**PLANNING BOARD  
TOWN OF EAST HAMPTON**

**PLANNING BOARD  
TOWN OF EAST HAMPTON  
WORK SESSION:  
March 11, 2020**

**Re:** Cohen/Tepper Lot Line Modification  
SCTM#300-167-3, 14, 15, 16, & 17

Wallace & Delaney Residence

MAP NO. 501  
MONTAUK VILLA PARK

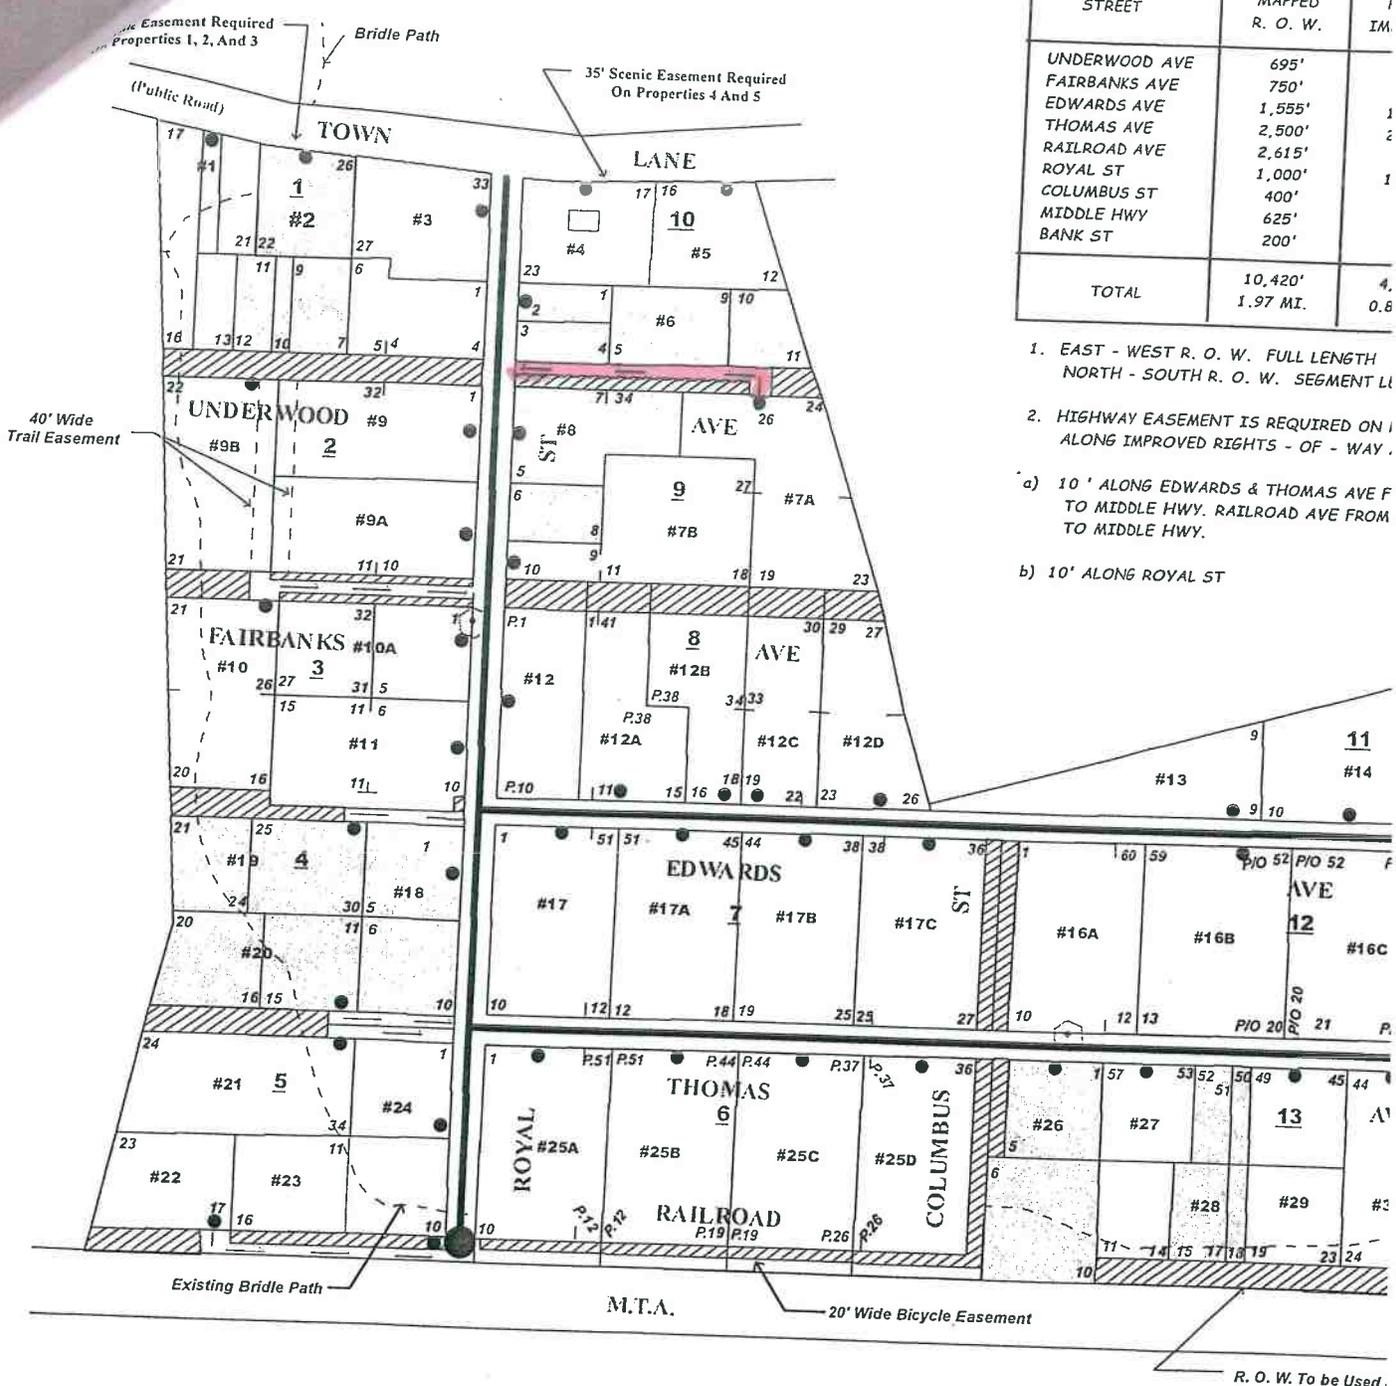
However, the Old Filed Map call for the northerly half of the 30' wide right of way of Royal Street to be opened as access to SCTM#300-167-3-20.9 and the southerly half of the right of way being abandoned. A driveway to lot 20.9 already exists in this 15' wide strip and the survey shows that it is within the area that the applicant wants to abandon, so would require the relocation of this driveway. It would also require a hearing and the notification of the property owner who is currently slated to acquire the entire 15' strip.

The applicant's proposal would also require a modification of the UR map to keep the center 15' of the 30' wide right of way open and the abandonment of 7.5' of the right of way to the north and 7.5' to south, rather than abandon to the center line. This would be an exception, as Old Filed Map abandonments are set so as each adjoining lot has a right

The Board should discuss with the applicant whether the lot line modification can be accomplished without a modification of the urban renewal map.

**Approximate location of proposed generator**

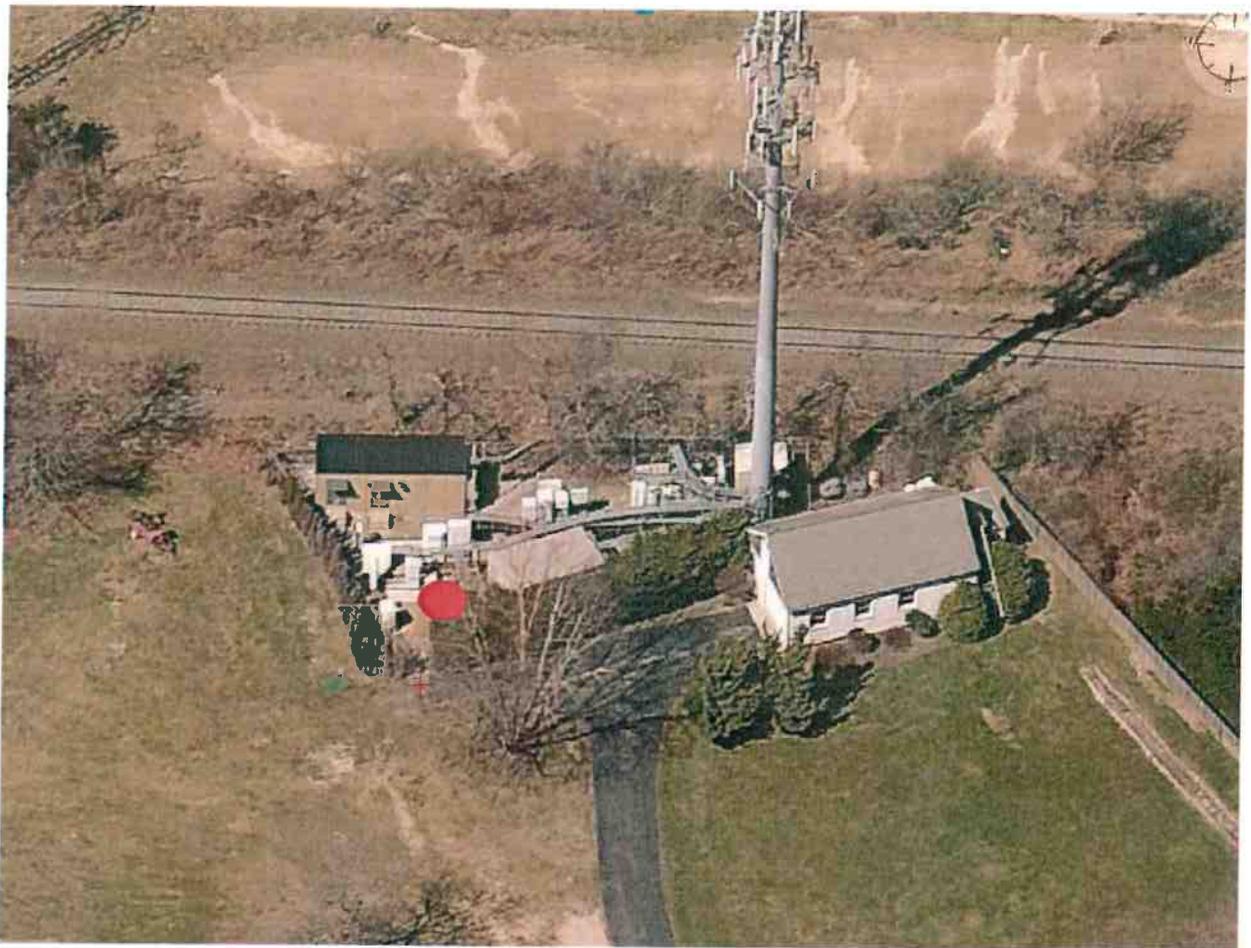
The generator is proposed in an existing equipment area over 400' from Main Street and currently partially screened by an evergreen hedge. The applicants and the Board may wish to discuss whether or not any additional screening is needed. It does appear based upon site inspection that the proposed location for the generator is already adequately screened as it is within an existing fenced-in equipment compound and screened by a large evergreen hedge.

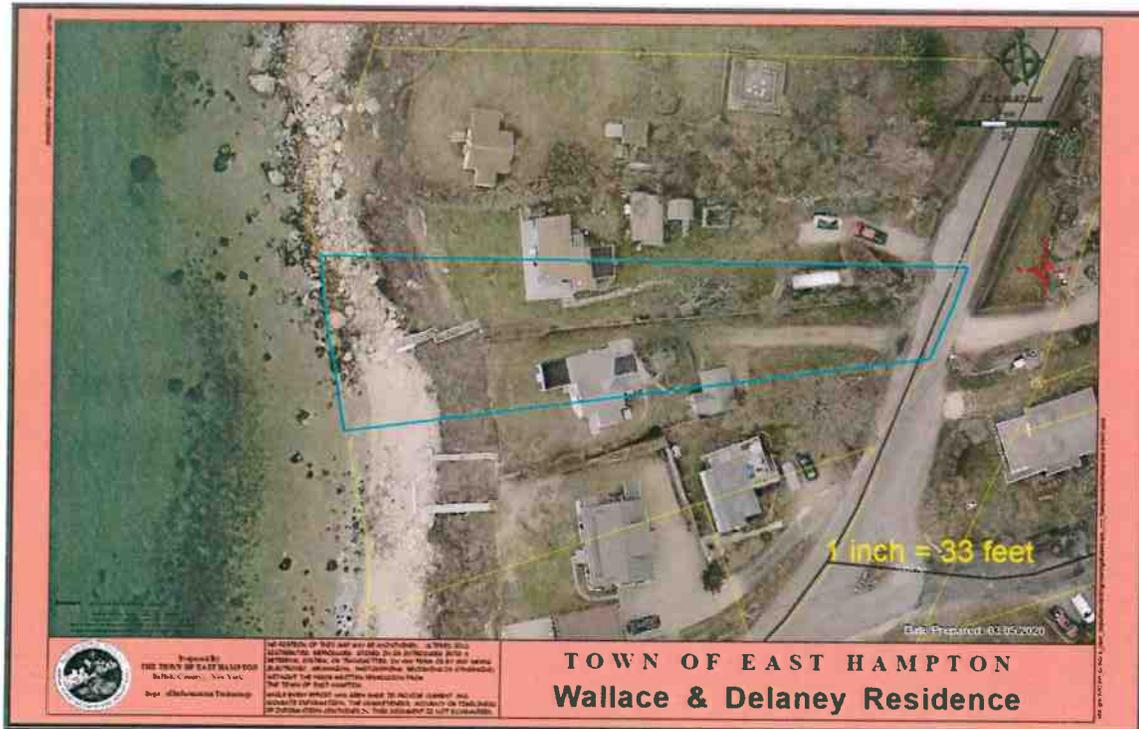
- The plans need to be revised to reflect the title of the site plan
- Renewal of prior approvals
- Natural Resource Special Permit
- Request of Variance from ZBA
- Revegetation Plan

**The proposed deck will replace the non-conforming portion of the residence; situated roughly 26' from the bluff crest and 75' from the mean high water**

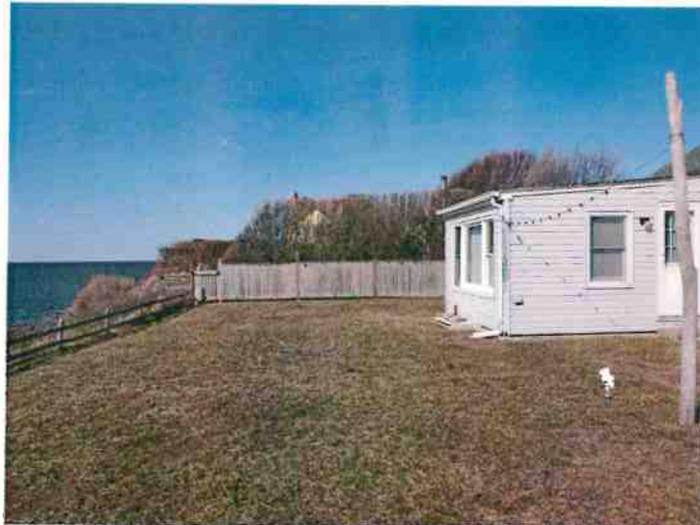
It appears that the applicant proposes to replace brick and sand patio, approved in 2010 but not constructed, with a larger deck. This new proposed deck will trigger the need for new variances due to the fact that the structure is situated roughly 26' from the bluff crest whereas a minimum 75' setback is required. Also, a wetland setback variance is needed as the deck is situated roughly 54.1'' from the mean high water, where 100' setback is required from tidal wetlands.
